MIL-R-63997B(AR)  
AMENDMENT 4  
31 July 1993

SUPERSEDING  
AMENDMENT 3  
25 March 1992

RIFLE, 5.56MM: M16A2

This Amendment forms a part of MIL-R-93997B(AR), dated 12 December 1986, and is approved for use by U.S. Army Armament, Munitions and Chemical Command and is available for use by all Departments and Agencies of the Department of Defense.

FIGURE 1. Targeting and accuracy diagram.

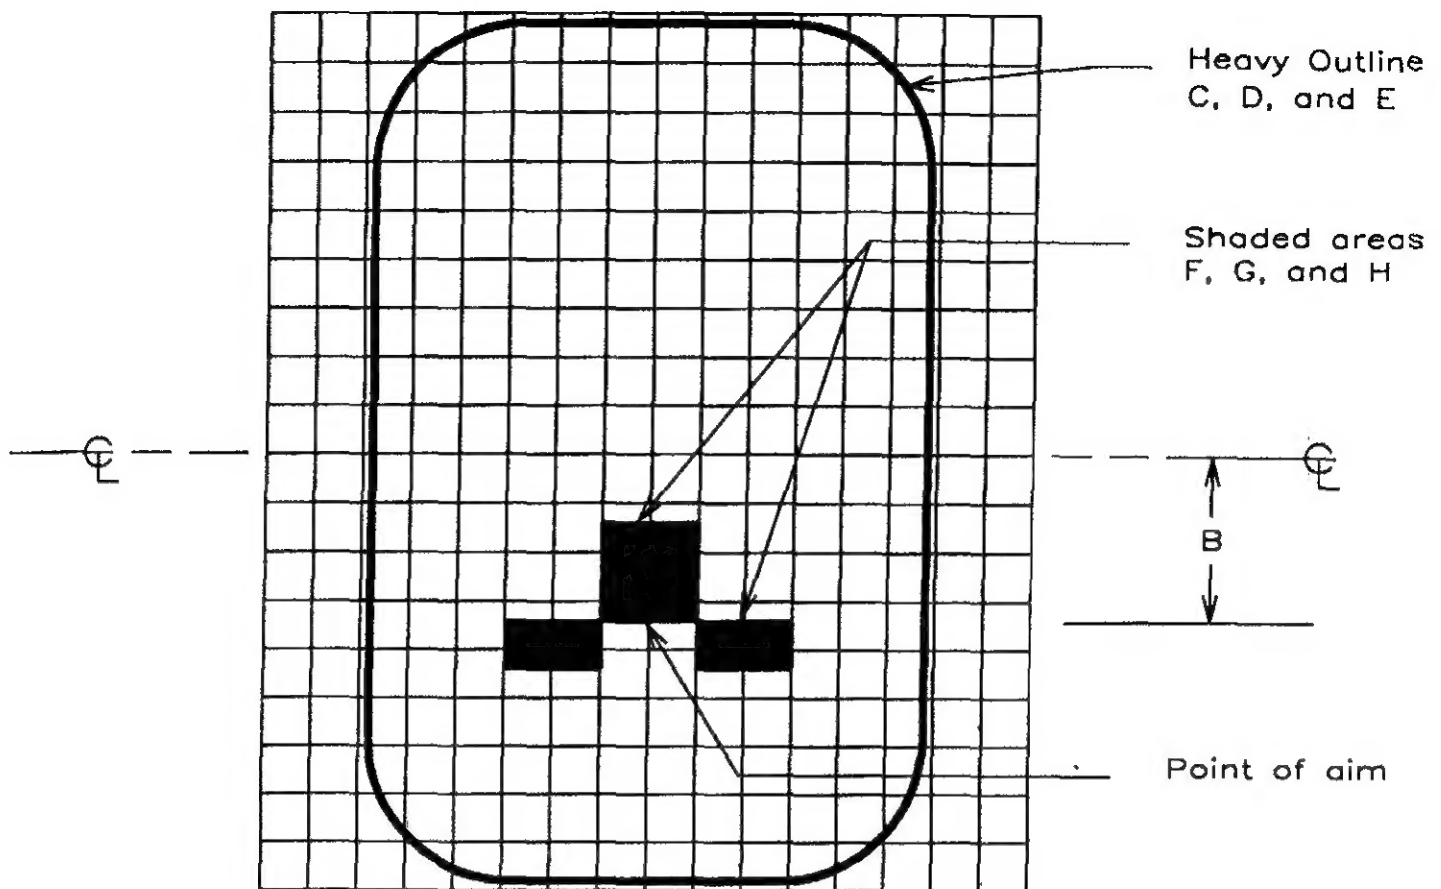
\* 3.4.6: Delete in it's entirety and substitute the following:

"3.4.6 Targeting and accuracy. A series of 10 rounds fired from each rifle at a range of 91.4 meters shall be within the extreme spread and targeting area (heavy outline) specified in Figure I when the front and rear sights are set as follows. The normal rear sight peep (sight rotated fully rearward) shall be used with the rear sight set centrally in the slot for windage within plus or minus five (5) clicks. The top edge of the front sight post flange shall be set flush to .030 inch below the bottom surface of the front sight slot. Ammunition shall be Government standard M855, 5.56mm ball cartridges conforming to Drawing 9342868 and shall have a vertical and horizontal standard deviation at 600 yards between 3.4 inches and 4.0 inches when measured in accordance with MIL-C-63989."
